# Rezoning Transportation Analysis

Petition Number: 2021-085

Date	Description
08-02-2021	First Review (WB)

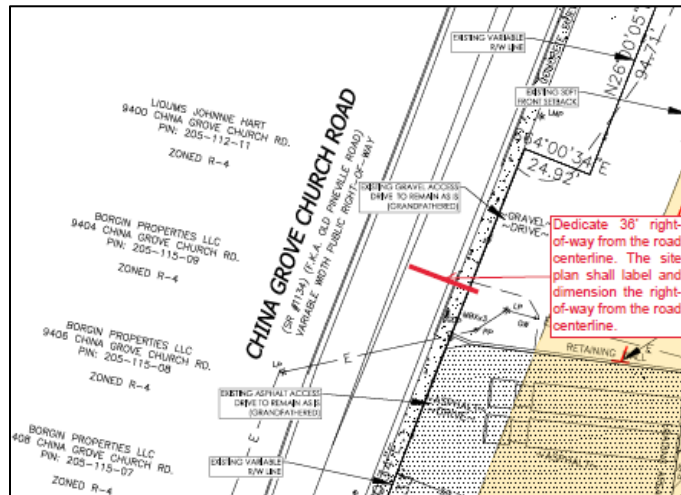
2. Revise site plan and conditional note(s) to commit to dedicate 36' right-of-way from the road centerline. The site plan shall label and dimension the right-of-way from the road centerline.

3. Revise site plan and conditional note(s) to commit to construct an 8-foot planting strip, and 5-foot minimum sidewalk on China Grove Church Road per CLDSM Standard U-07 and in accordance with Charlotte BIKES Policy. The site plan shall label and dimension both items from the back of curb and gutter and road centerline.
4. Site plan and conditional note(s) revisions are needed to remove all reference to all "grandfathered" infrastructure. All transportation infrastructure must be revised to meet current CDOT CLDSM standards, including driveway installation per the Charlotte Driveway Regulations.
